100th Ave. Northeast Corridor Design  
Advisory Group Meeting #3 Summary  
September 13, 2016 5:00 – 8:00 p.m.

Kirkland City Hall, Peter Kirk Room, 123 5th Ave., Kirkland, WA 98033

Figure 8: Enlarged Detail of Non-Motorized Design for Pedestrian Users

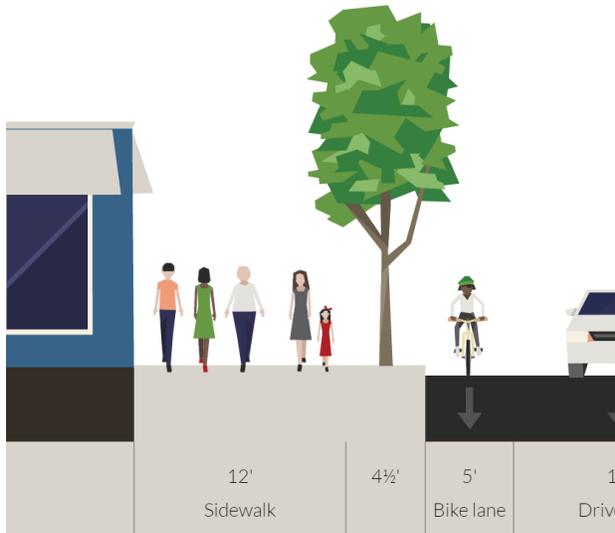
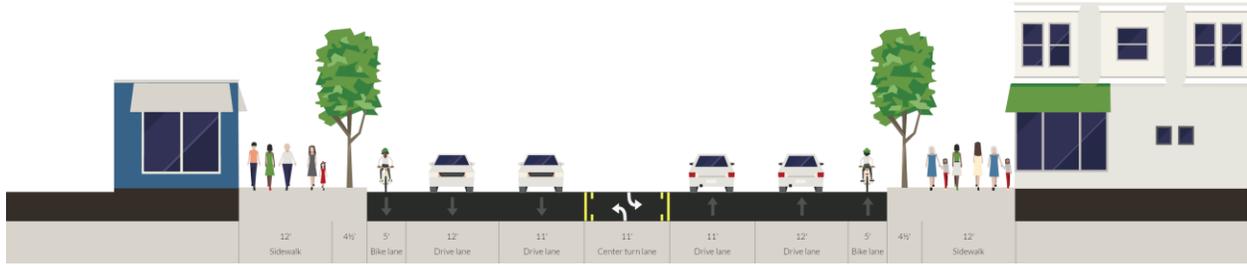
\*\*The widths shown in this non-motorized section exceeded 20.5-ft, the maximum space available for non-motorized improvements on each side of the street, including a 1-foot space between back of sidewalk and adjacent properties. One foot of space would need to be deducted from either the bike lane buffer, landscaping strip or sidewalk on each side of the street.

Figure 10: Enlarged Detail of Non-Motorized Design for Bicycle Users

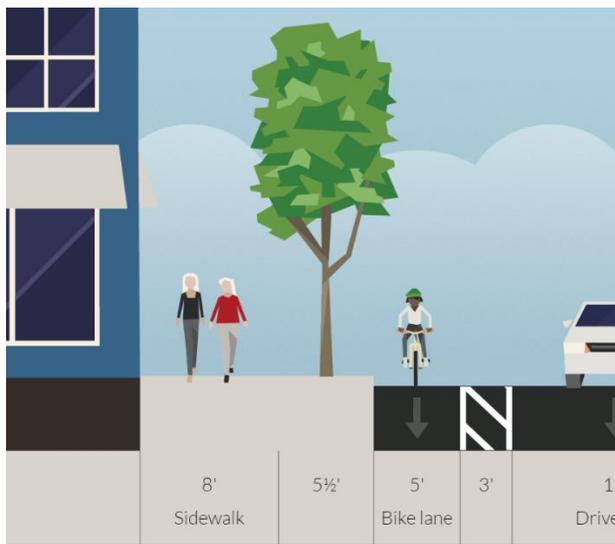
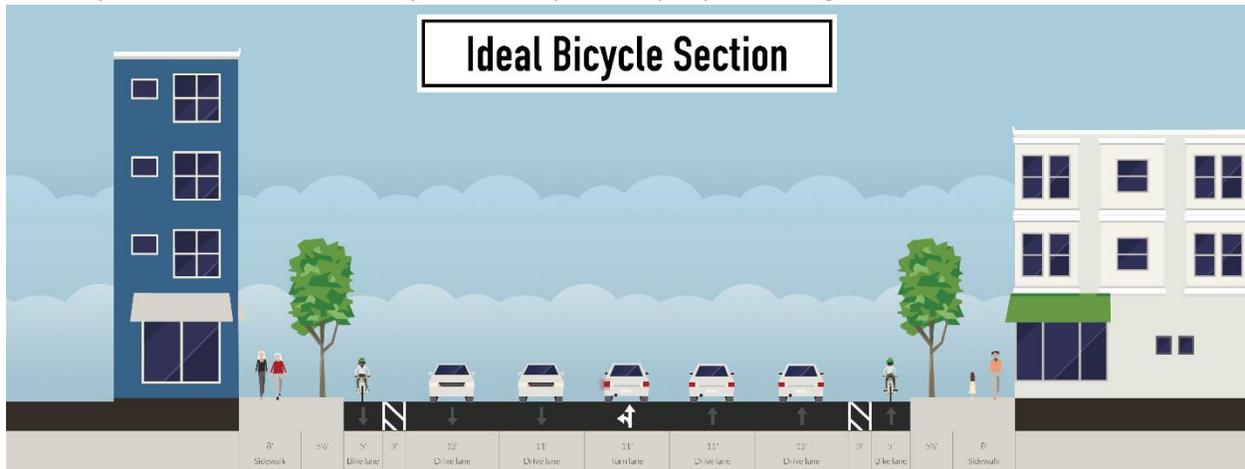
Group 3 adjusted their ideal pedestrian section to better accommodate bicyclists by narrowing the sidewalk on each side to eight feet and providing a 3-foot buffer between the bicycle lane and traffic. They also increased the landscaping strip by one foot on each side. However, they concluded that perhaps this was not ideal for either people walking or biking because it puts bicyclists within the

roadway and reduces the overall (perceived) space for people walking.

\*\*The widths shown in this non-motorized section exceeded 20.5-ft, the maximum space available for non-motorized improvements on each side of the street, including a 1-foot space between back of sidewalk and adjacent properties. One foot of space would need to be deducted from either the bike lane buffer, landscaping strip or sidewalk on each side of the street.

**Conceptual Layout 1:**

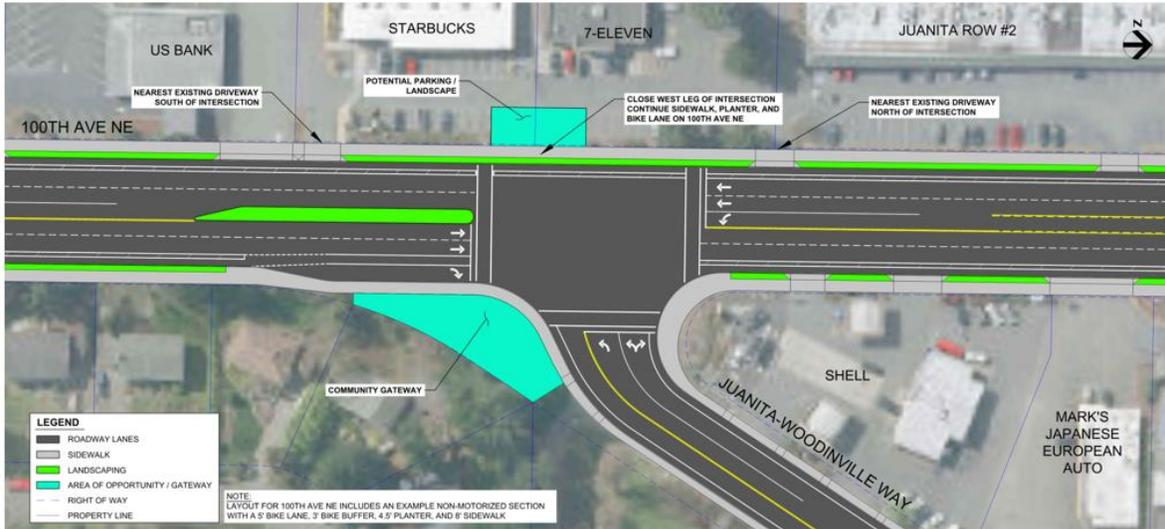
Doug McFadyen suggested a staggered intersection with coordinated timing of stop lights.

- West – **Close**, East – **Realign**

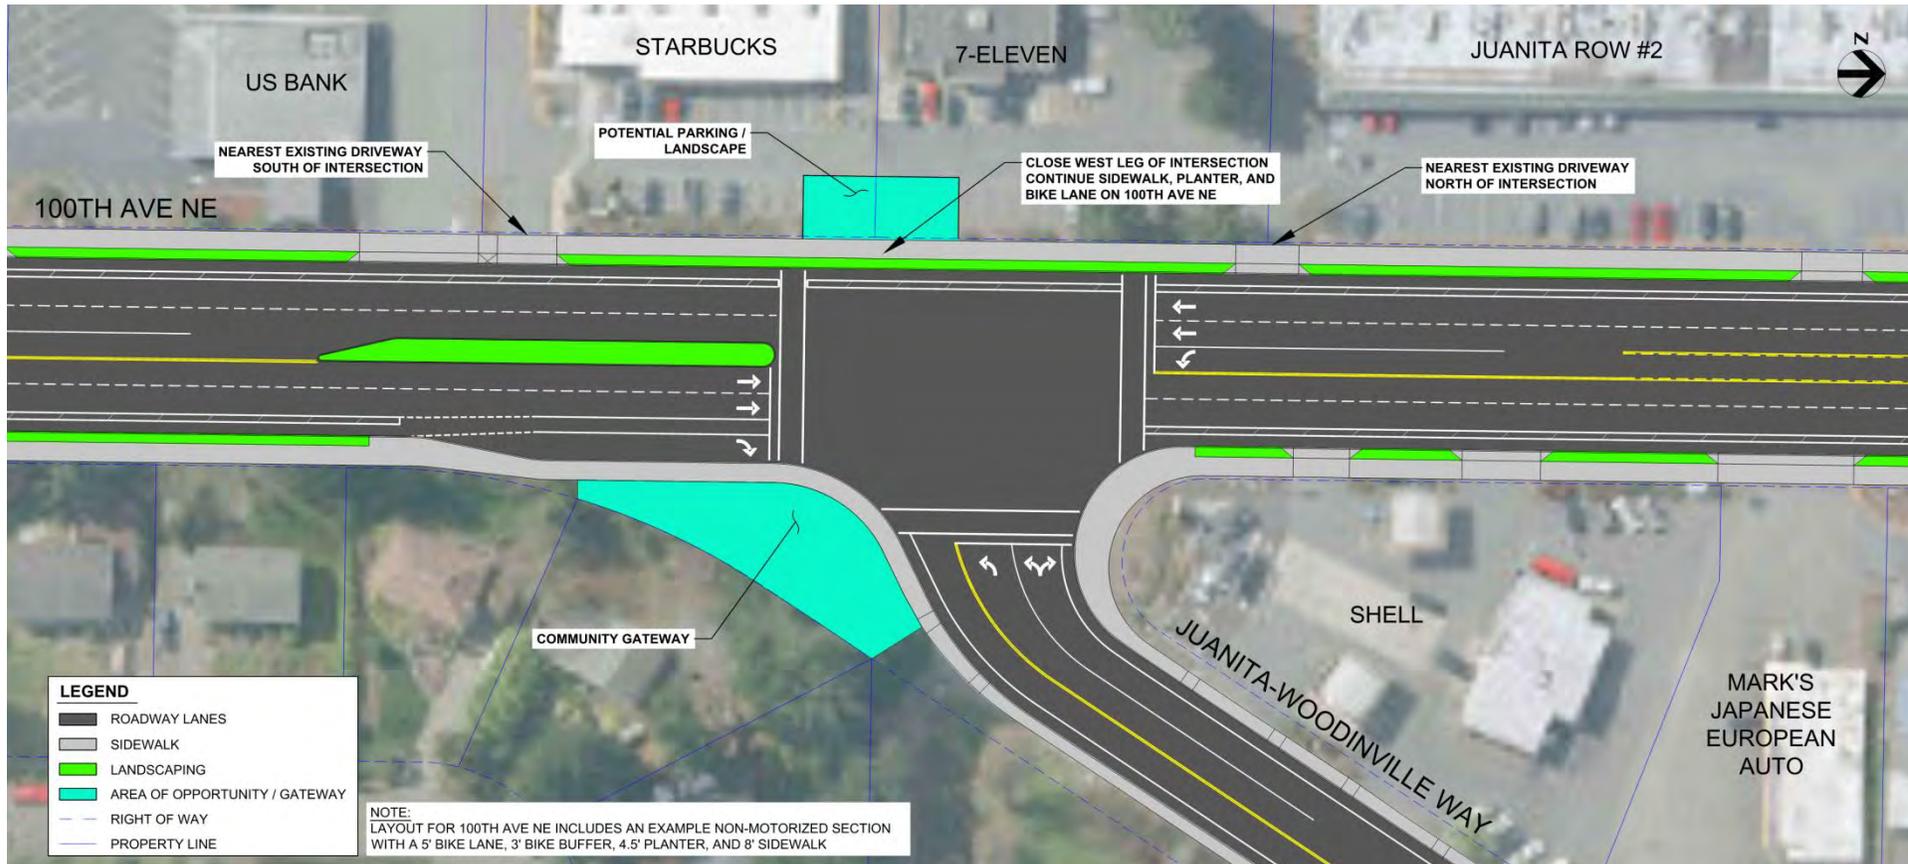
Marianna advocated for the second option because she believed it would be safer, especially for pedestrians, and probably force drivers to slow down along the corridor.

Tiffany Martin added that from a pedestrian standpoint, Conceptual Layout 2 is great, but raised the concern that closing the west side would create a major cut through for drivers, similar to having another roadway next to 100th Ave. NE.
